CREATION DATE : 10-JUL-12
BID NUMBER: 7451778,1
TITLE: NEW SECURITY NETWORK - CCRI

ADDENDUM # 1

RFQ #7451778

PRE-BID QUESTIONS

FIELD HOUSE

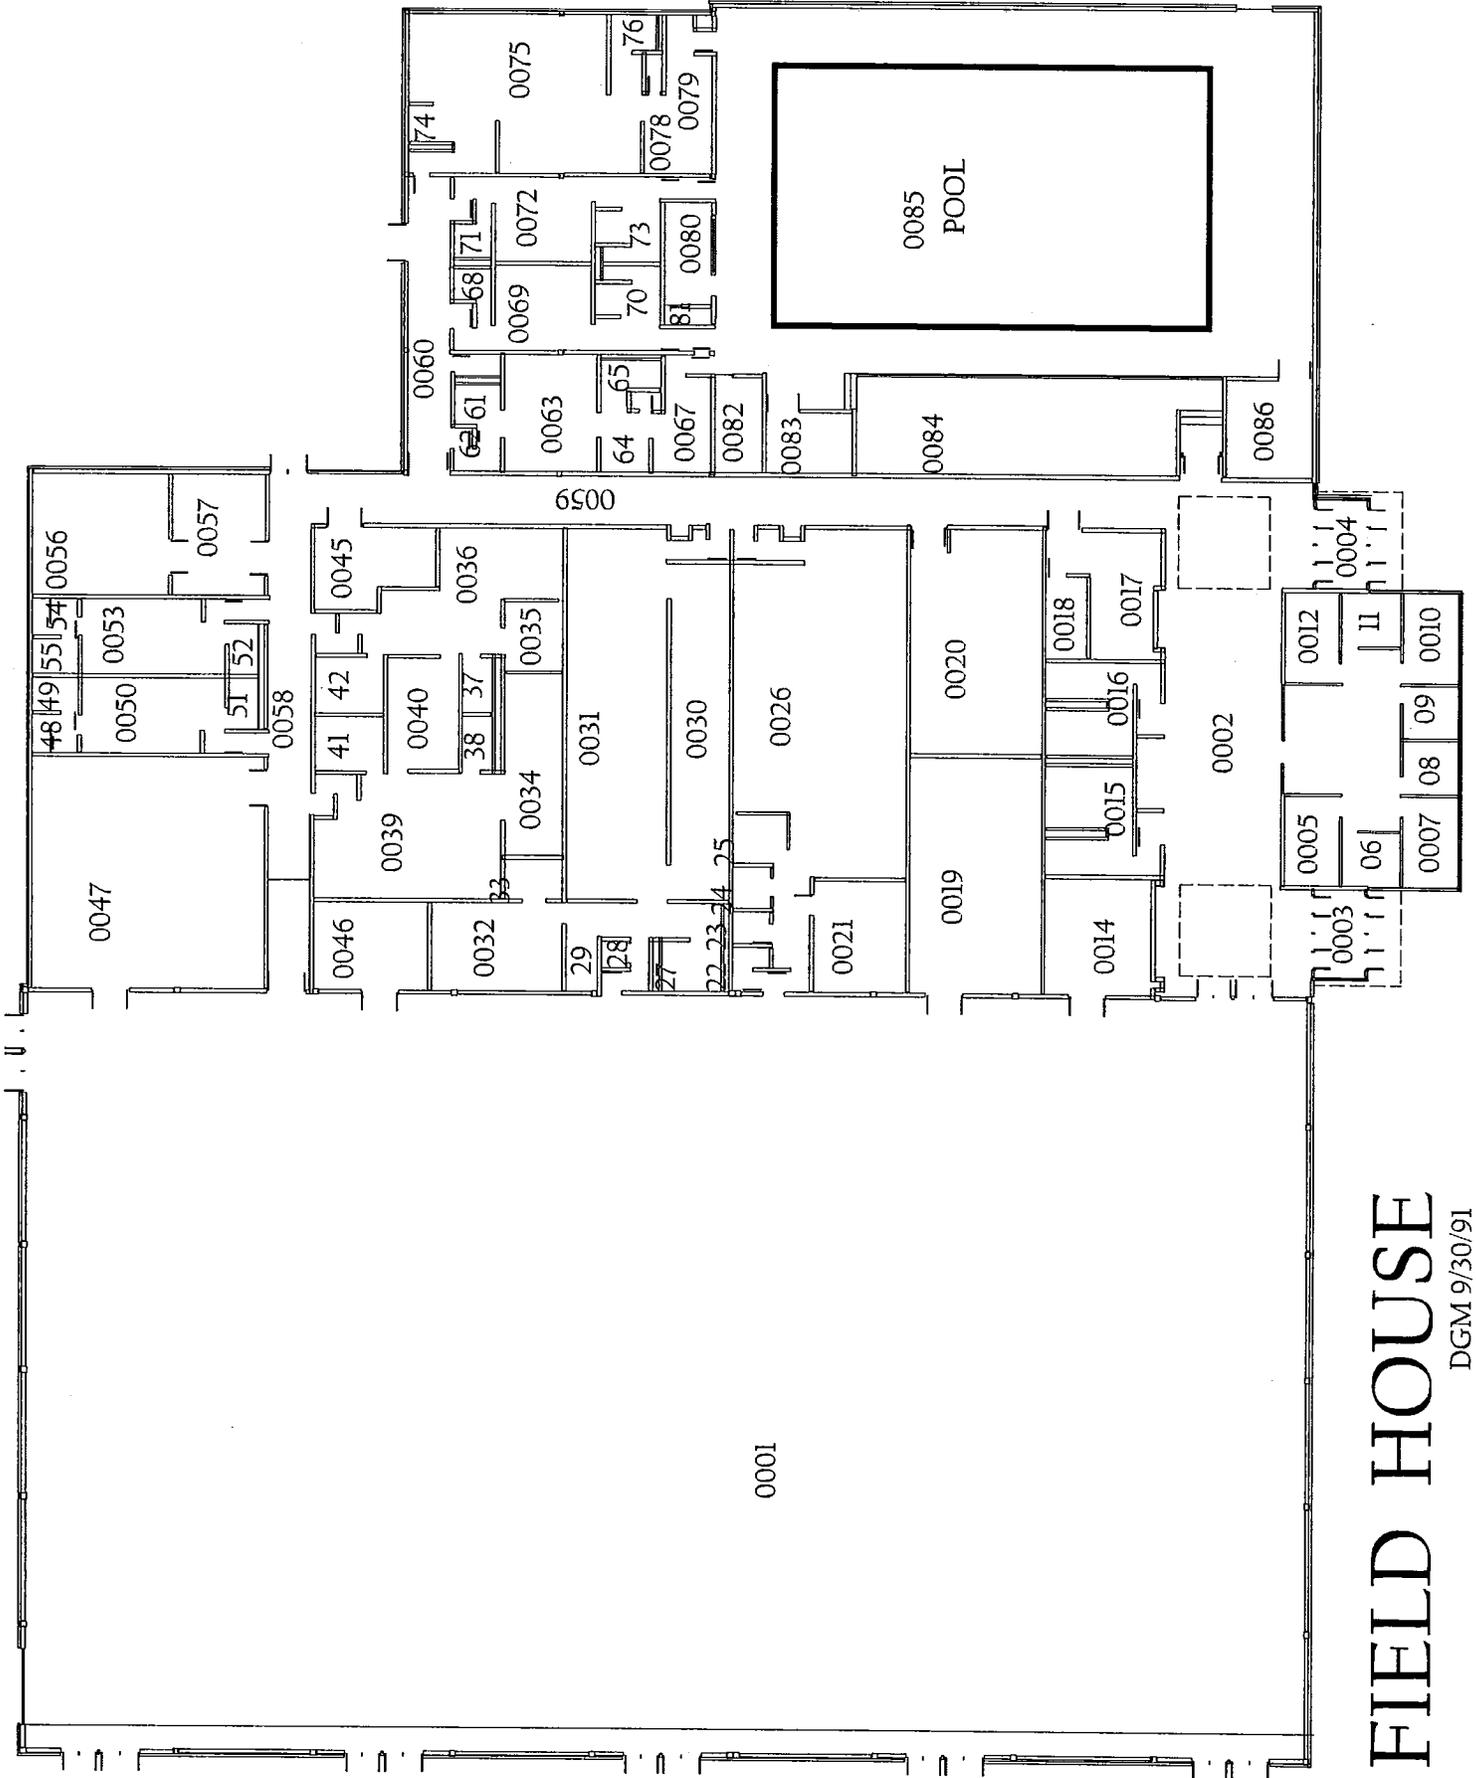
21). WILL EXISTING CONDUIT BE ABLE TO BE USED TO FOR GARAGE?

22). WILL CONDUIT GET CONTRACTOR INTO FACILITY (GARAGE)?

23). DOES FIELD HOUSE SYSTEM NEED OFF-SITE MONITORING?

ANSWER: CCRI WILL PROVIDE CONDUIT RUN FROM GARAGE INTO FIELD HOUSE ROOM #0047 ABOVE CEILING. GARAGE ITSELF REQUIRES ALL NEW INSTALLATION AND CONDUIT AS REQUIRED.

ANSWER: SEE QUESTION 21 ABOVE.

ANSWER: YES. FIELD HOUSE SYSTEM IS INDEPENDENT FROM MAIN BUILDING. VENDOR IS TO PROVIDE PRICE FOR OFF-SITE MONITORING FOR LINCOLN FIELD HOUSE. SEE QUESTIONS #4 ABOVE FOR DETAILS.
